Board of Zoning Appeals March 14, 2024 @ 9:00am Council Chambers First Floor, 345 High Street Hamilton, Ohio 45011

#### BZA 2024-03-004: Variance Requests for 877 NW Washington Blvd

#### BZA 2024-03-005: Variance Requests for 1558 Main Street

PROPOSED ELEVATION SCALE: 1/4" = 1'-0"

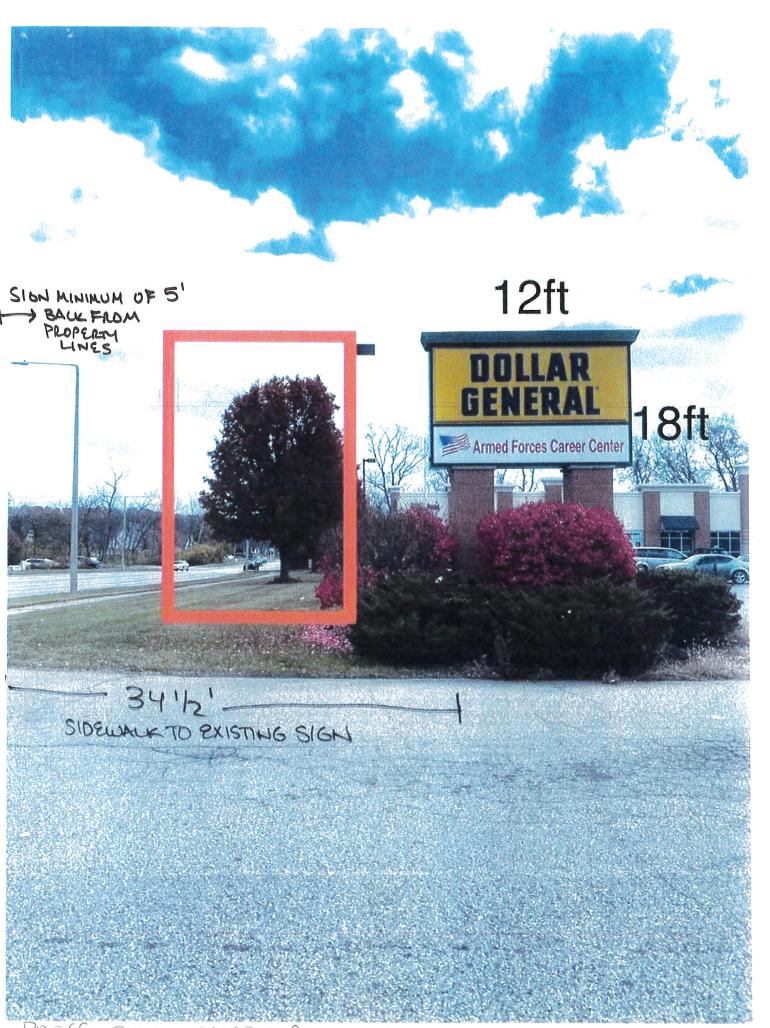
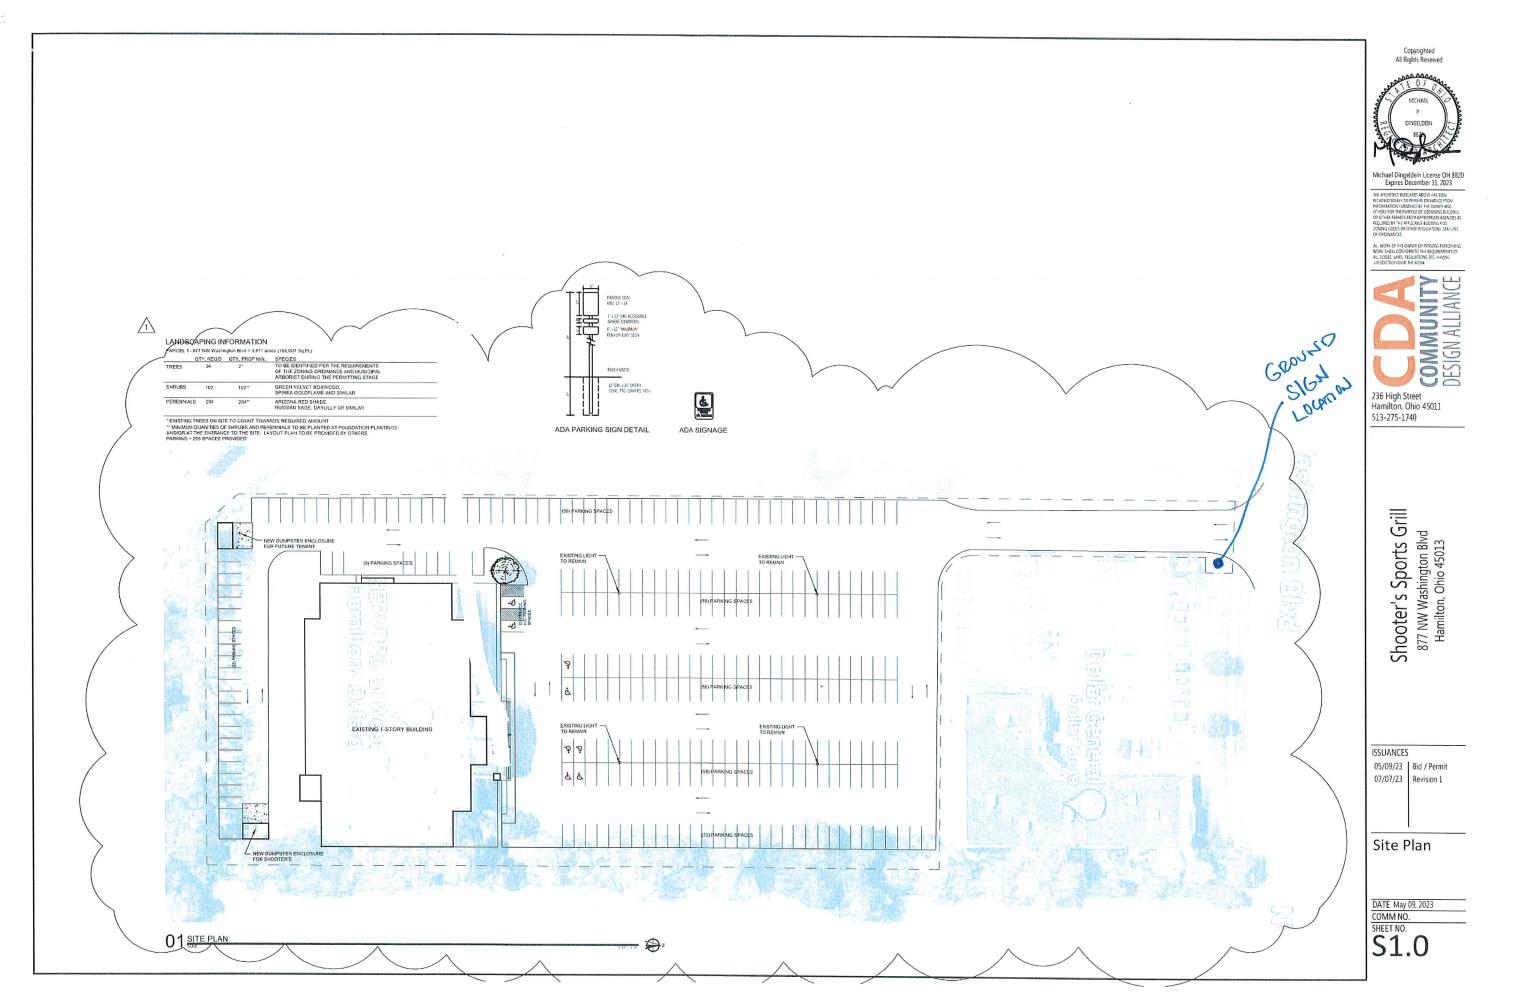
The proposed sign is approximately fourteen (14) feet in height by twelve (12) feet wide. The sign will have a base that is three (3) feet high and constructed of stone/ masonry. The sign as proposed will be internally lit, located next to the current sign for Dollar General. As can be seen on the aerial views of the property line, there is an area carved out for signage. The Applicant has stated that they will meet the landscaping requirements for monument signs.

The dimensions of the proposed sign, based upon the calculation of .75 x 270, are within the City of Hamilton's regulations. The applicant meets all other requirements as proposed today.

Staff Comment: On its face, the Variance does appear to be substantial. However, due to the lot being an odd shaped, panhandle lot, the frontage is approximately 58 feet wide while the lot is actually 277 feet wide. The sign, based on lot dimensions and not just frontage, is within code.

LEFT ELEVATION (WEST)

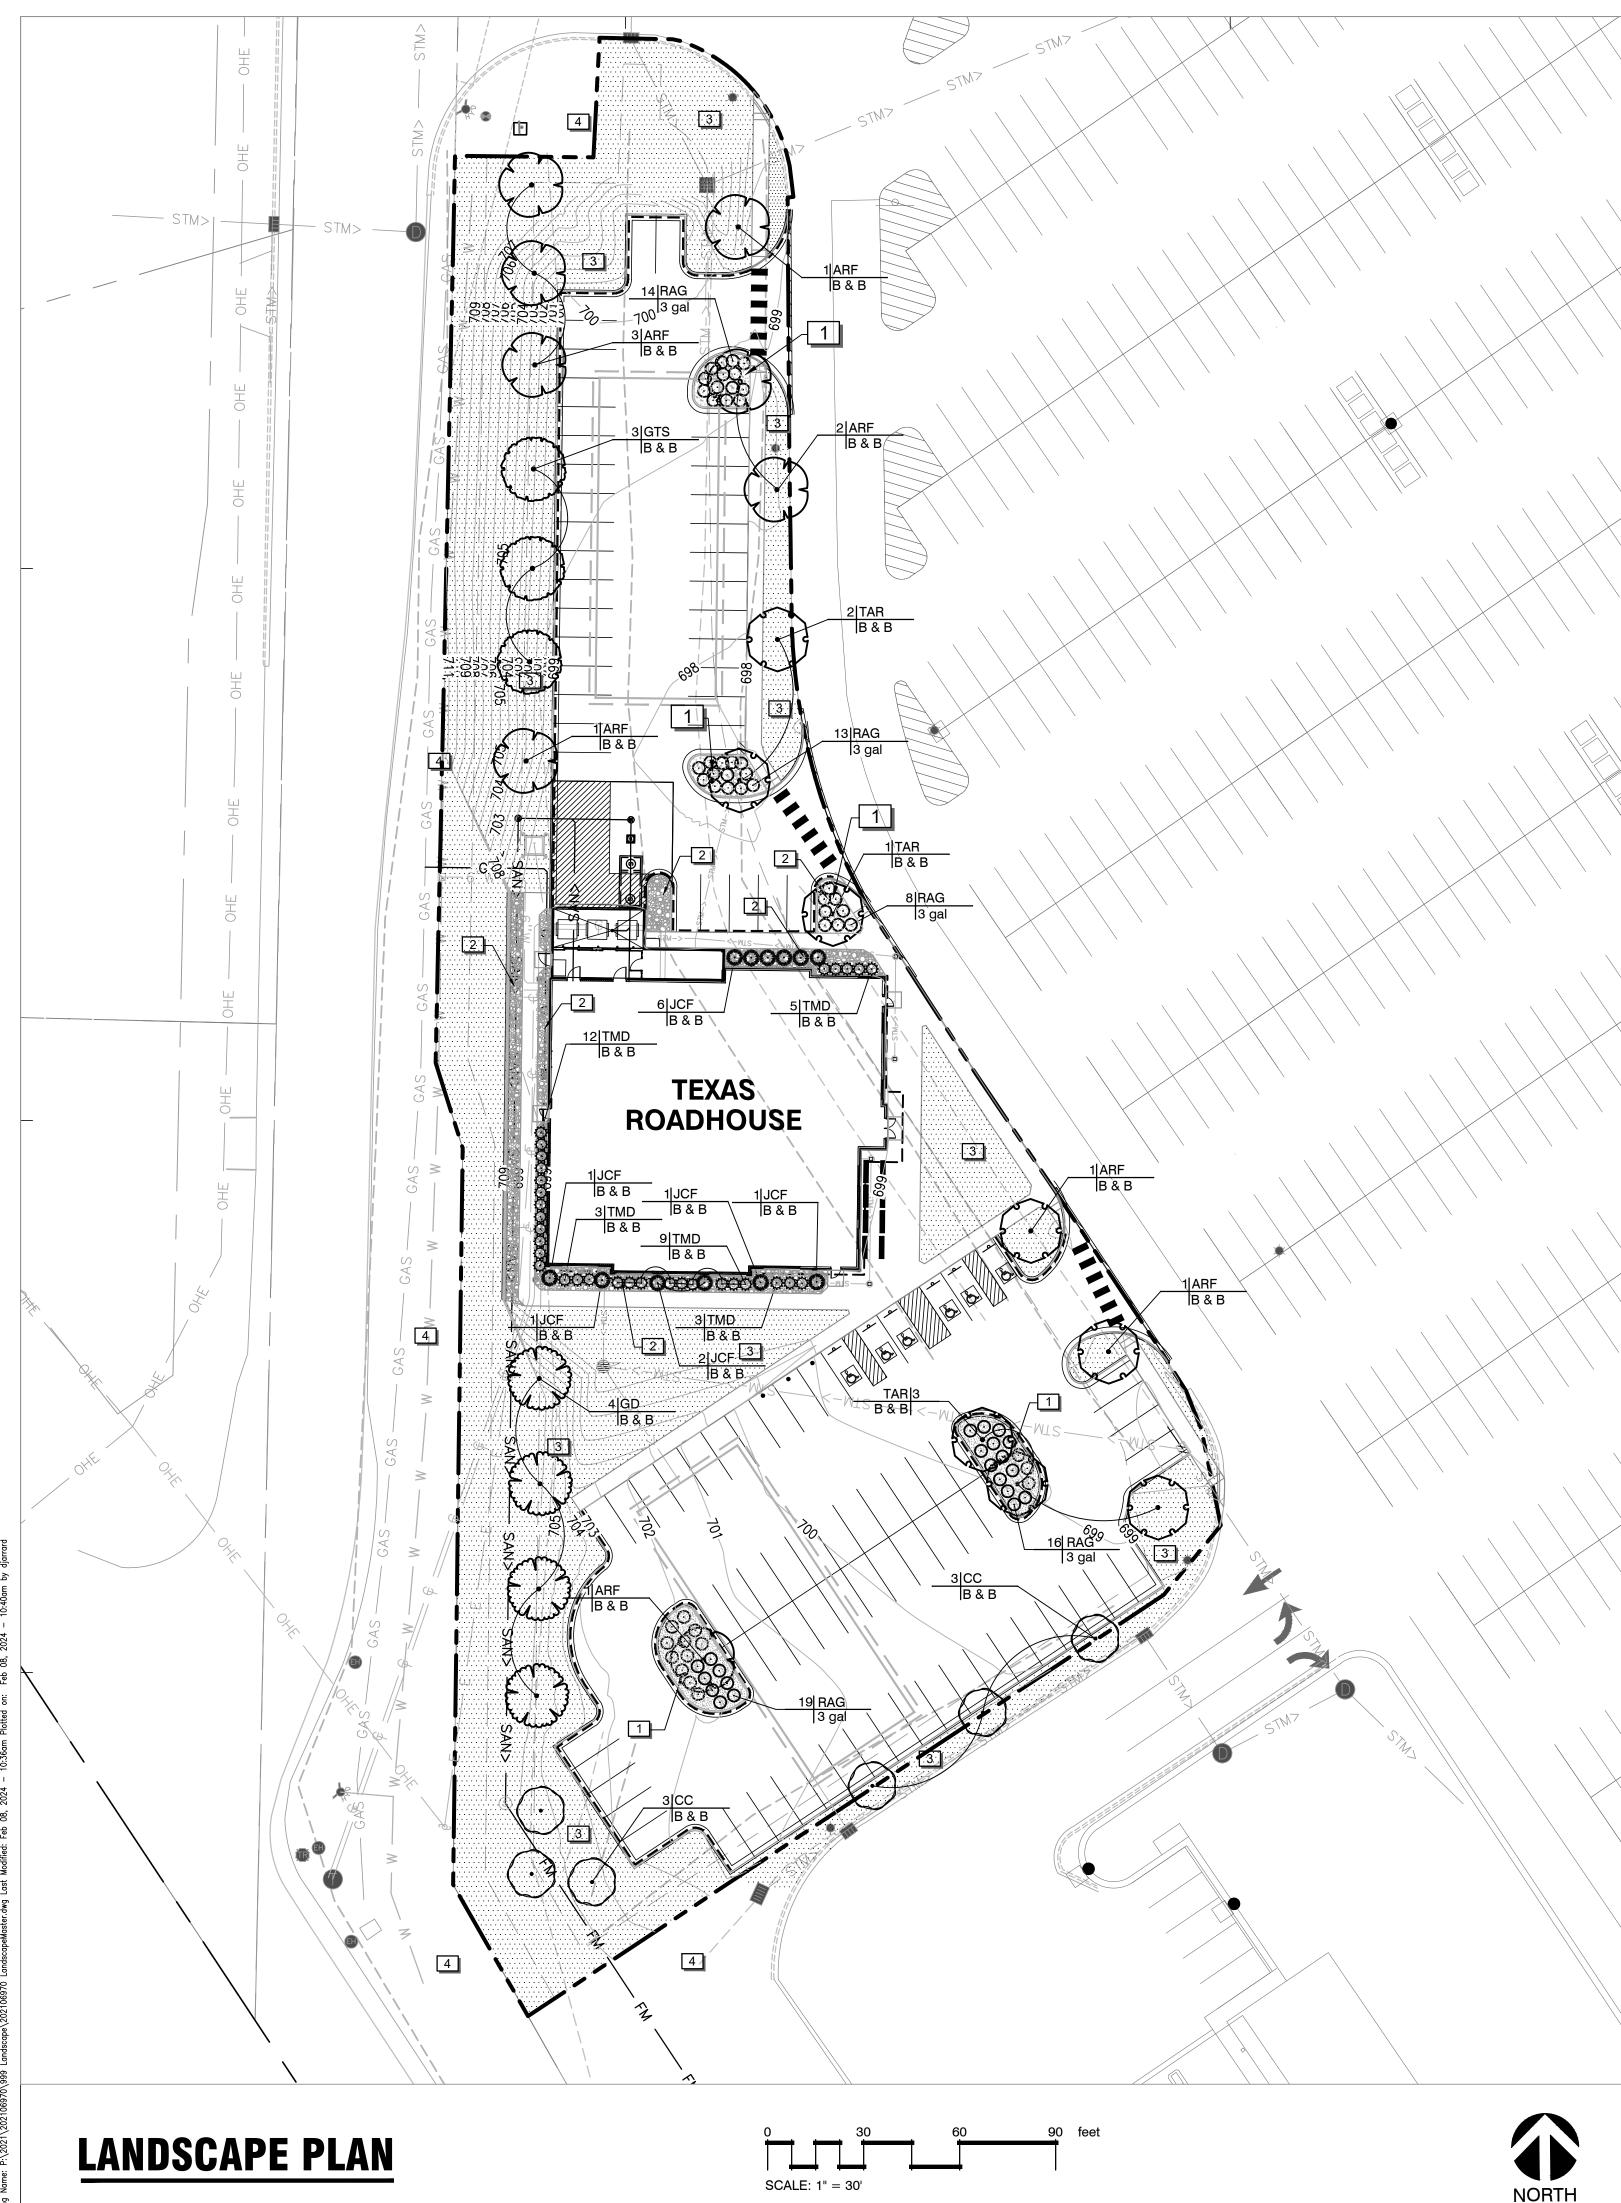
The west elevation is 94.3 feet long and requires 28.3% (94.3 x 30%) transparency. There are two (2) windows on the west elevation which account for 12.7% transparency. The two (2) windows are on the right side of the elevation which is within the dining area. None of the windows are the required six (6) foot in height, which is a 100% variance request.

The left side of the elevation which contains no transparency or spandrel is the back of business operations including the restrooms, mechanical, and dry storage.

This elevation is also the side which faces an approximate 20 foot decline from the road to the business and will require a retaining wall, which staff believes will reduce visibility from the road.

The West Elevation contains 12.7% transparency where 30% is required. A variance request of 17%. The west elevation will face Gardner Road which has a twenty foot grade from the road to the business and will also require a retaining wall. Due to the elevation change and back of business operations, the lack of transparency is not substantial

• The Left Elevation (West facing Gardner Road) provides 10.62% transparency with 26.56% Spandrel/Faux Windows for a total glazing of 37.18%. The northern half of the elevation is back of house operations which would view into the restrooms, storage and mechanical rooms. Please refer to the building's floor plan that is included in the application. Additionally, due to the site conditions the building's elevation will be 20-feet below Gardner Road and therefore not highly visible from the right-of-way. Please refer to the enclosed line of site exhibit for view corridor from Gardner Road to the building elevation.
